DEVELOPMENT APPLICATION ASSESSMENT REPORT

Application Number:	DA2021/0133
----------------------------	-------------

Responsible Officer:	Thomas Prosser
Land to be developed (Address):	Lot 102 DP 605991, 62 Hudson Parade CLAREVILLE NSW 2107
Proposed Development:	Alterations and additions to a Dwelling House
Zoning:	E4 Environmental Living
Development Permissible:	Yes
Existing Use Rights:	No
Consent Authority:	Northern Beaches Council
Delegation Level:	DDP
Land and Environment Court Action:	No
Owner:	Michael Anthony Still
Applicant:	Catherine Finlay

Figure 1: Line highlighted in red for section of height non-compliance

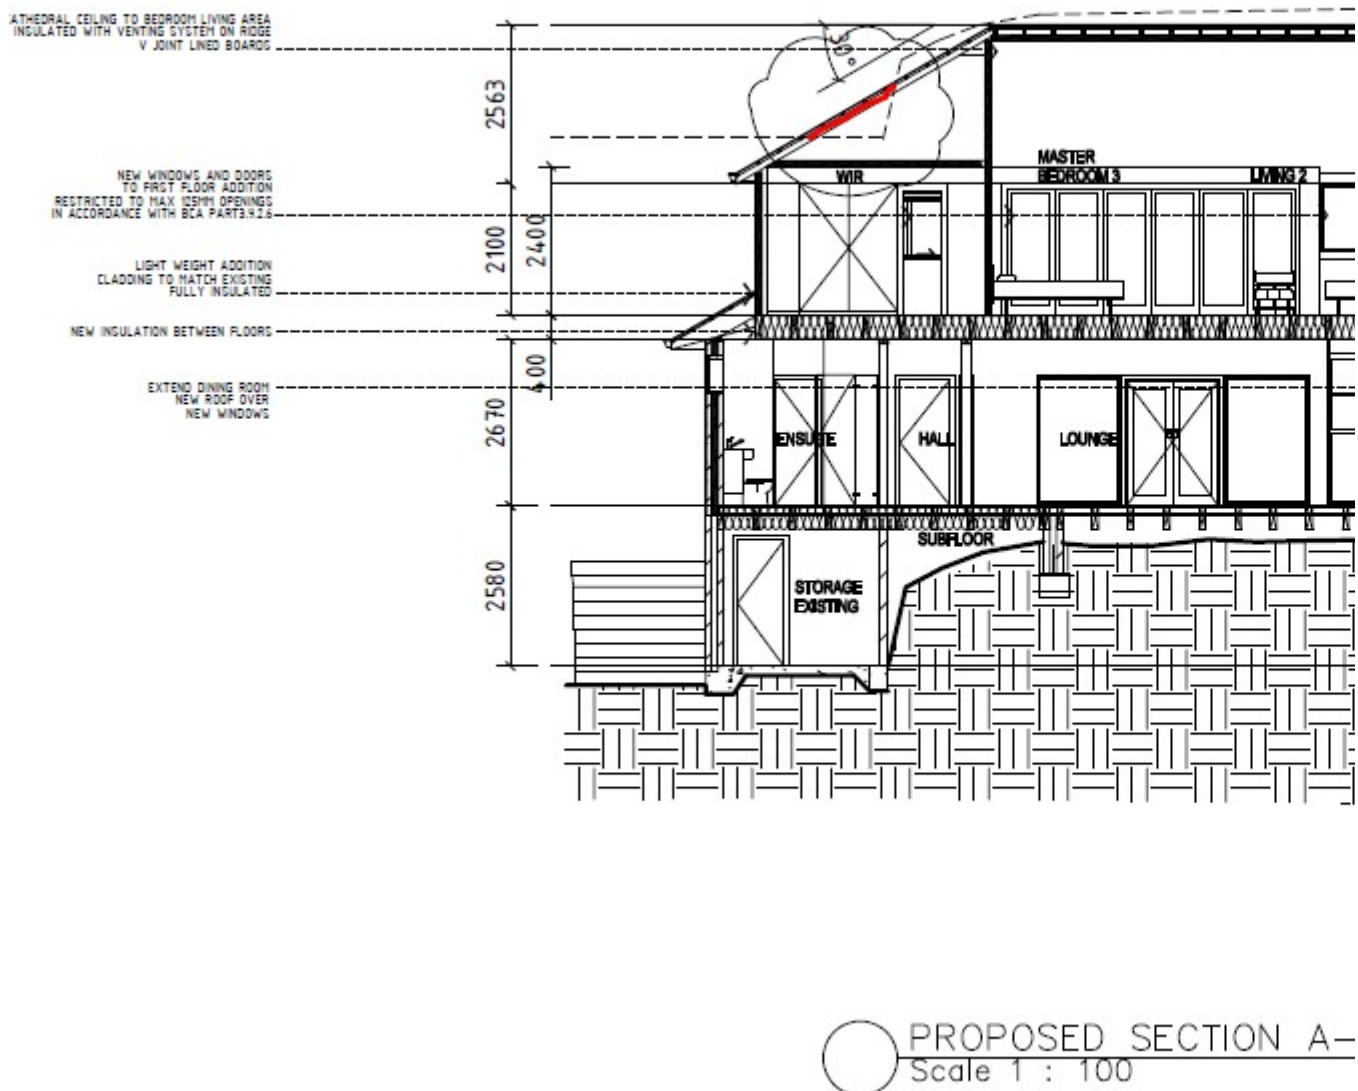
Description of non-compliance:

Development standard:	Height of buildings
Requirement:	8.5m
Proposed:	9.4m
Percentage variation to requirement:	10.6%

The area of non-compliance is minor and occurs at a section of the site that is down slope. Further, the pitched roof style would complement the existing form of the dwelling so as to provide a better visual presentation than a flat roof.

It is agreed that the non-compliance is caused partly by the slope of the site, and that the design of a sloped roof provides visual presentation that complements with the existing built form.
